## Addendum 2 Solicitation 20-99324 East Superior Street Reconditioning

This addendum serves to notify all bidders of the following changes to the solicitation documents:

SHEET NO. 35A OF 64 SHEETS

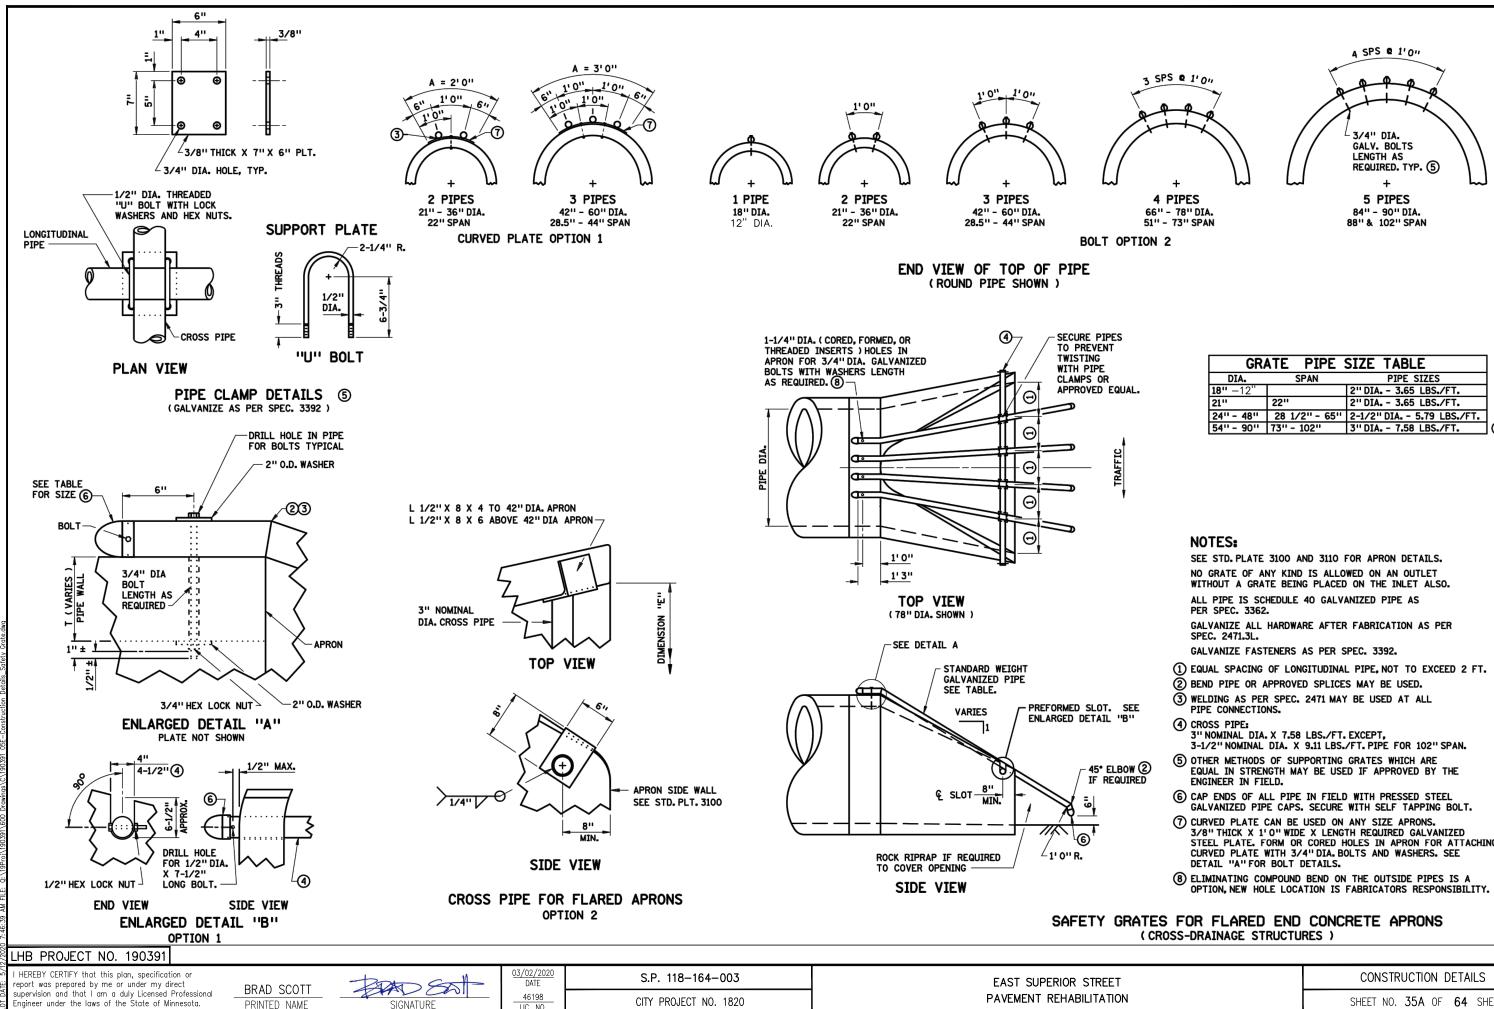
- 3. On Plan Sheet 2, Note 8 shall not apply to item 2106.507 "EXCAVATION-COMMON (CV)"
- 4. Add Note 20 on Sheet 3 as follows:
  - a. Standard Plate 3128 shall not apply. Standard plates 3100 and 3110 shall apply. Apron shall be reinforced concrete (metal aprons are not acceptable). Refer to Sheet 35A for requirements.

- 5. On Sheet 3, the new Note 20 shall apply to the following items:
  - a. 2501.502 12" RC SAFETY APRON AND GRATE DESIGN 3128.
  - b. 2501.502 18" RC SAFETY APRON AND GRATE DESIGN 3128.

- c. 2501.502 21" RC SAFETY APRON AND GRATE DESIGN 3128.
- 5. Attached Sheet 35A is hereby added to the Plans.
